Access Compliance Report

Public Rights-of-Way

(Curb Ramps)

Intersection ID: 43744	Main Street: RED_CLAY_LN	Cross Street: EARTHENWARE_DR	Location: W
ADA ID: A81066F15DE2	Ramp Type: Perp	Initial Pass/Fail: Fail	Overall Compliance: No
Severity Score: 33.75			
Codes/Mitigation Info/Possible Solution		Field Measurements/Component Compliance

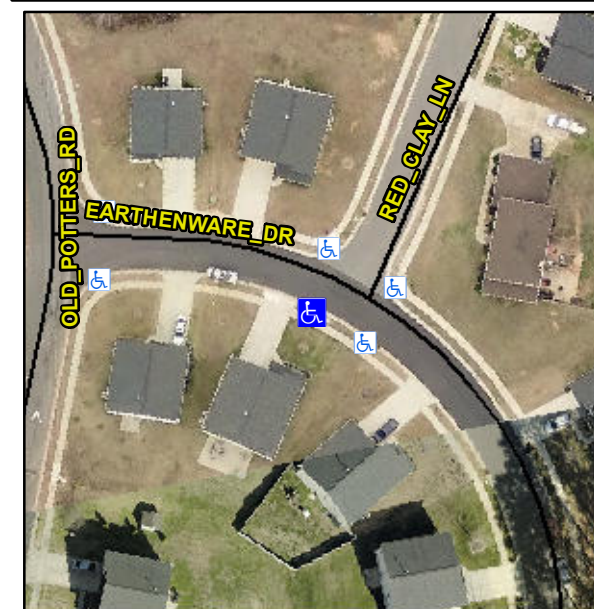
Not Found, R304.5.1, R304.2.2

Compliance	Description	Data	Compliance	Description	Data
N/A	Ramp Length (in)	48.0	No	Ramp Slope (%)	12.3
No	Ramp Width (in)	47.0	Yes	Ramp XSlope (%)	1.5
N/A	Flare Type LT	N/A	N/A	Flare Type RT	N/A
N/A	Flare Slope LT (%)	N/A	N/A	Flare Slope RT (%)	N/A
N/A	Flare Traversable LT?	N/A	N/A	Flare Traversable RT?	N/A
N/A	Landing Length (in)	N/A	N/A	DWS Provided?	N/A
N/A	Landing Width (in)	N/A	N/A	DWS Contrast?	N/A
N/A	Landing Slope (%)	N/A	N/A	DWS Length (in)	N/A
N/A	Landing X Slope (%)	N/A	N/A	DWS Full Width?	N/A
N/A	Landing Curb? (Y/N)	N/A	N/A	DWS Offset (in)	N/A
N/A	Shared Landing?	N/A			
N/A	Gutter Ponding?	N/A	N/A	Gutter Slope (%)	N/A
N/A	Gutter Lip Ht (in)	N/A	N/A	Gutter X Slope (%)	N/A
N/A	Painted X Walk1?	No	N/A	Painted X Walk2?	N/A
	X Walk 1 Direction	To NE		X Walk 2 Direction	N/A
N/A	X Walk 1 Width (in)	N/A	N/A	X Walk 2 Width (in)	N/A
	X Walk 1 Slope (%)	3.9		X Walk 2 Slope (%)	N/A
	X Walk 1 X Slope (%)	1.2		X Walk 2 X Slope (%)	N/A

Remove & Replace Entire Ramp.
